PLAT COMMITTEE

January 10, 2024

Case Number:	2023-PLT-093
Property Address:	4903 and 4909 West Washington Street (Approximate Address)
Location:	Wayne Township, Council District #17
Petitioner:	Axum Auto Plus, LLC, by Meles Mezgebo
Zoning:	C-3 / C-4 (FF) (FW)
Request:	Approval of a Subdivision Plat to be known as Mezgebo's Manor Addition, a replat of a part of Lot 12 in Mary J. Smitson's Subdivision, dividing 3.92 acres, into two lots.
Waiver Requested:	None
Current Land Use:	Retail Commercial
Staff Reviewer:	Linda Ahlbrand, Principal Planner II

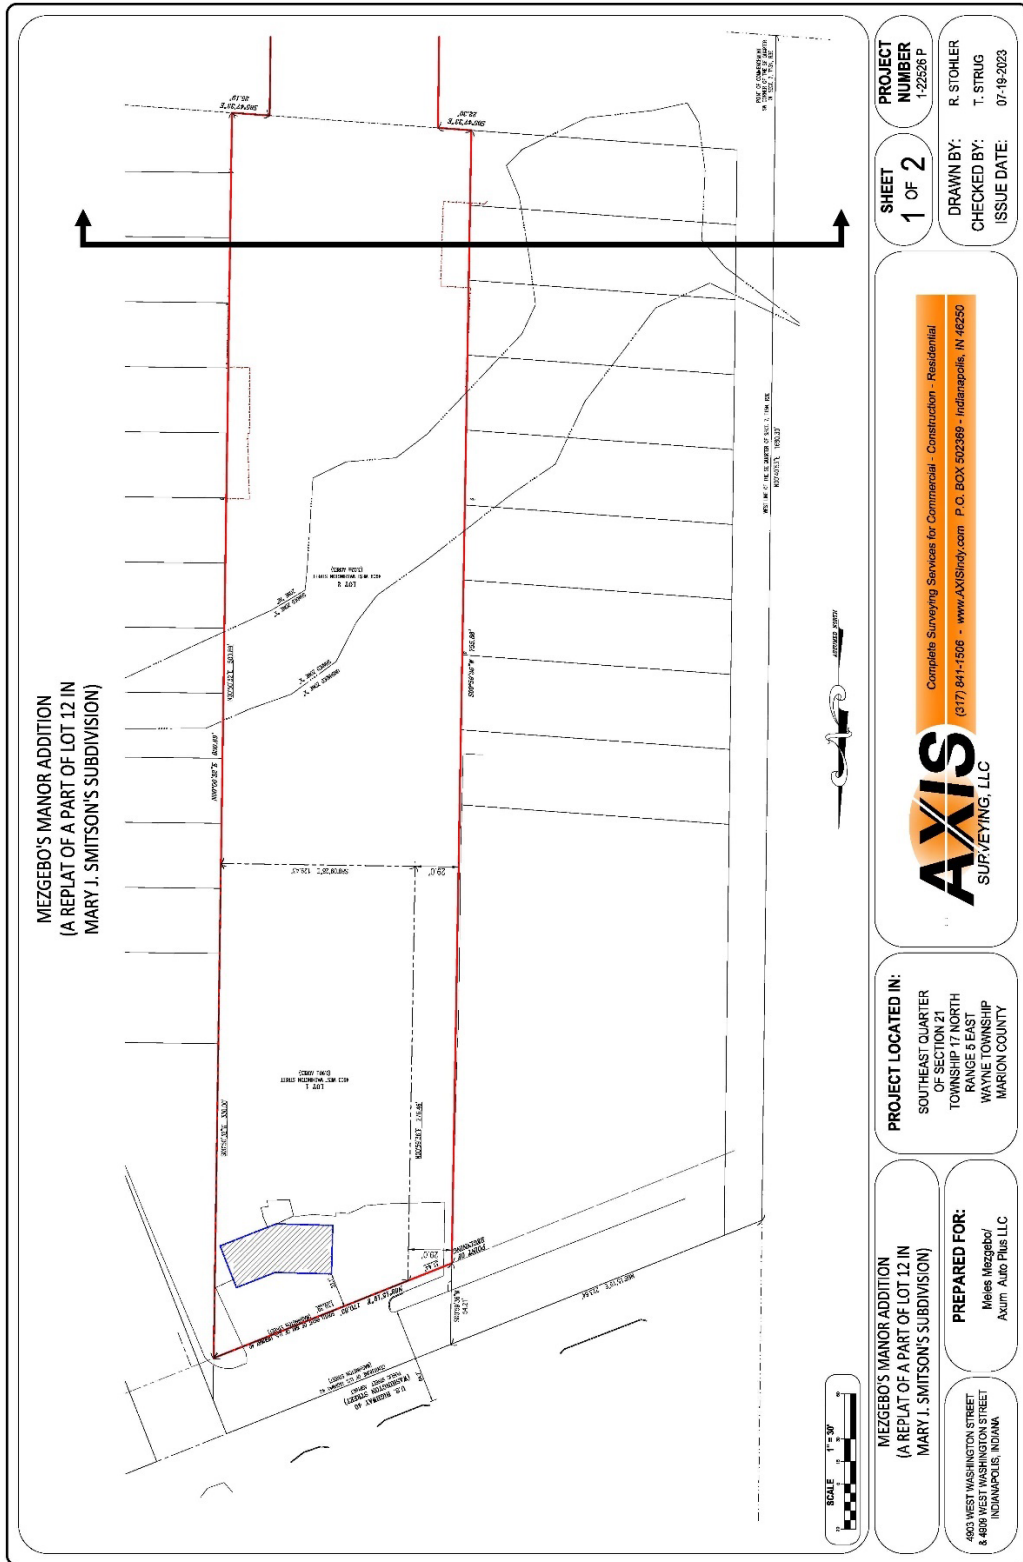
This site is zoned C-3 and C-4 and is developed with a restaurant on the C-4 portion and a pole barn on the C-3 portion. This request would divide the 3.92 acres into two lots. Lot One would be 0.90 acre, would front on Washington Street and would contain the existing restaurant and pole barn. Lot Two would be 3.02 acres, would have 29 feet of frontage on Washington Street and would be available for development under the C-3 district. The proposed plat meets the standards of the C-3/C-4 zoning classification and the subdivision regulations.

Both lots would front on Washington Street. Lot Two would gain access to Washington Street via Lot One. An access easement should be provided (See Condition #11). No new streets are proposed as part of this petition.

Staff recommends that the Plat Committee **approve** and find that the plat, file-dated November 20, 2023, complies with the standards of the Subdivision regulations, subject to the following conditions:

9. That the plat restrictions and covenants, done in accordance with the rezoning commitments, be submitted prior to recording the final plat.
10. That all the standards related to secondary plat approval listed in Sections 741-207 and 741-208 of the Consolidated Zoning and Subdivision Ordinance be met prior to recording the final plat.
11. An access easement shall be provided on Lot One allowing ingress/egress for Lot Two to the existing driveway prior to recording the final plat.
